04V-118

VEHICLE RECALL

SC288

SUBJECT: INCORRECT FRONT STEER AXLE BRAKE CHAMBERS — CV MODEL CHASSIS EQUIPPED WITH 18,000 OR 20,000 LB. AXLES

Figure 1 — Type 20 and Type 24 Brake Chamber Identification

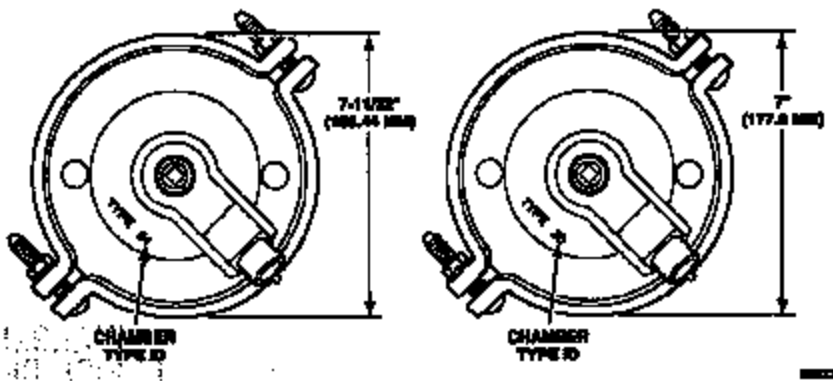
1. Secure the chassis for service, apply the parking brakes and block the wheels to prevent the vehicle from moving.
2. Open the hood to access the front axle brake chambers.
3. Inspect the front brake chambers to determine chamber type. The chamber type (Type 20 or Type 24) is embossed on the pressure side of the chamber. If the chamber type cannot be determined, measure the chamber diameter. A Type 24 chamber measures 7-11/32" (186.44 mm) in diameter. A Type 20 chamber is 7" (177.8 mm) in diameter.

The front axle brake chambers on all affected chassis must be inspected and replaced with Type 24 brake chambers (part No. 5554-1427001) as required.

If it is determined that the chamber is a Type 20, replace as follows:
